**Department of Planning and Zoning**

**TO:** Design Advisory Board  
**FROM:** Scott Gustin  
**DATE:** February 25, 2014  
**RE:** 14-0747SD, 1891 North Avenue

**Request:** Subdivide two lots into three lots, remove existing single family house, construct two duplexes and one single family house.

DRAWN	CCE
CHECKED	MEC
SCALE	1" = 20'
DATE	10/31/13
JOB NO.	29104
SHEET	C-1

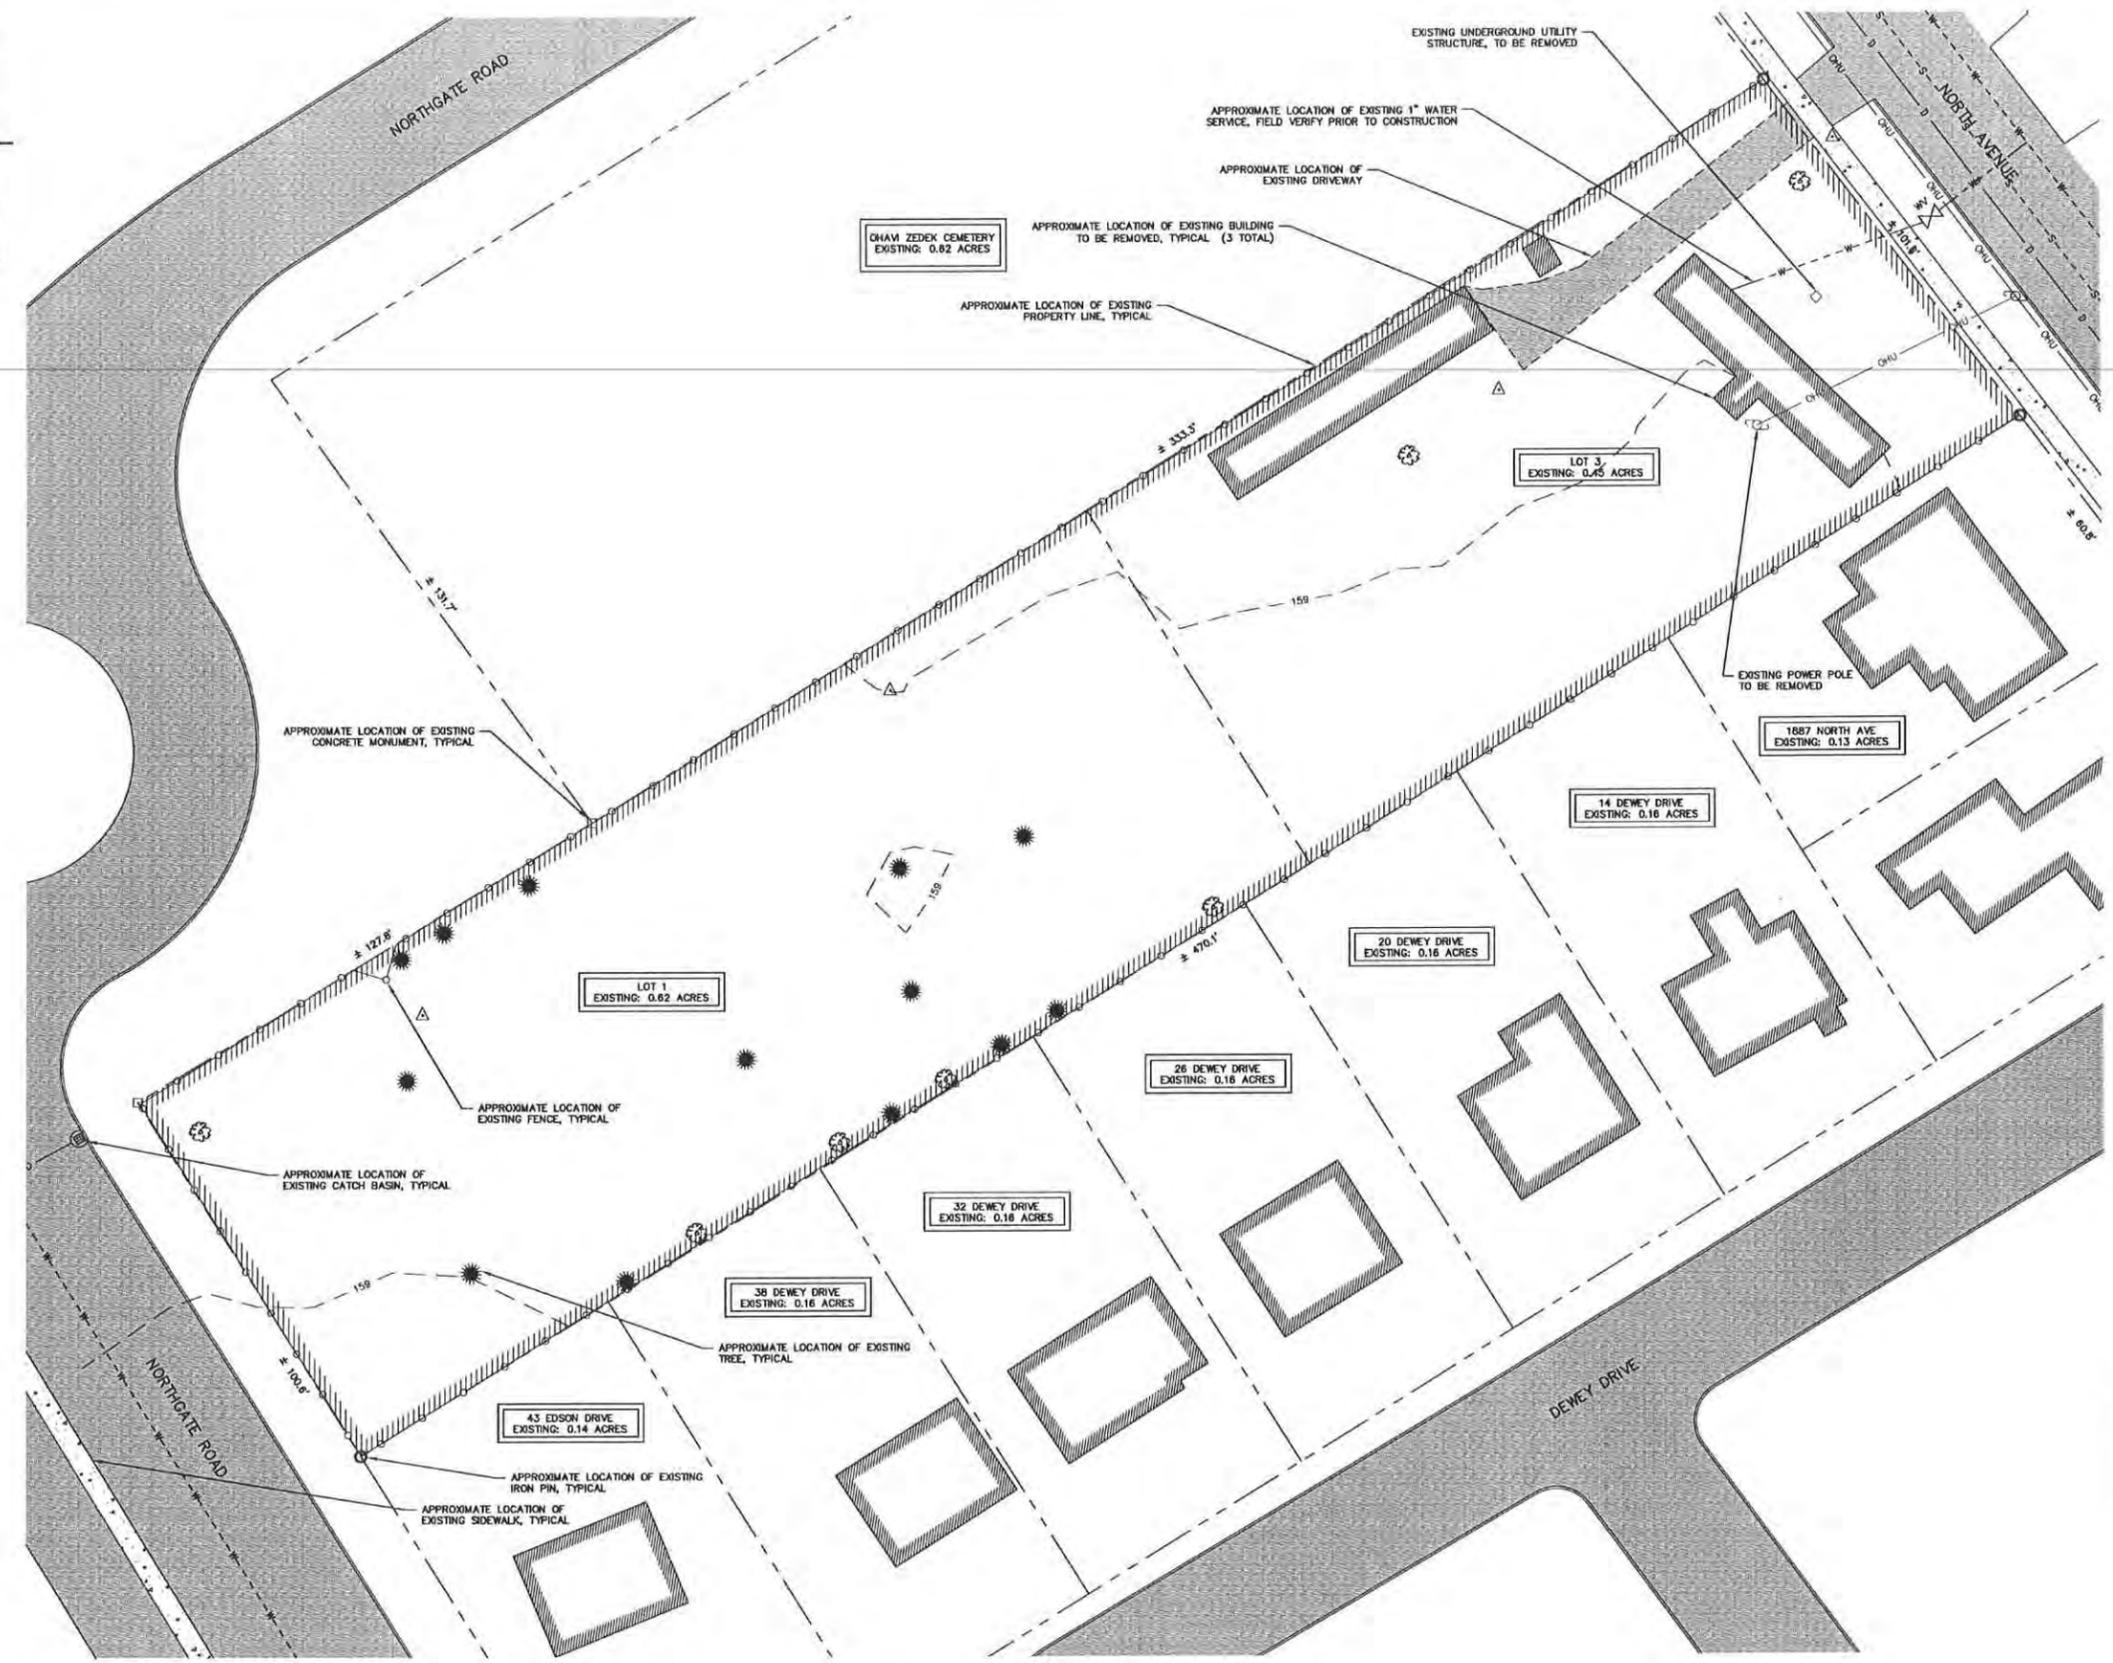
Very basic landscaping information has been provided. Between sheet C-1 which notes "existing tree to be removed" (perhaps all of them) in the legend and sheet C-2 which notes "existing tree" and "proposed tree" in the legend, it is unclear which existing trees (if any) will remain. Clarification is needed. New trees amount to four new white pines and two new red maples. A much more robust landscaping plan is needed in order to define spaces within the development and to screen parking areas and utilities.
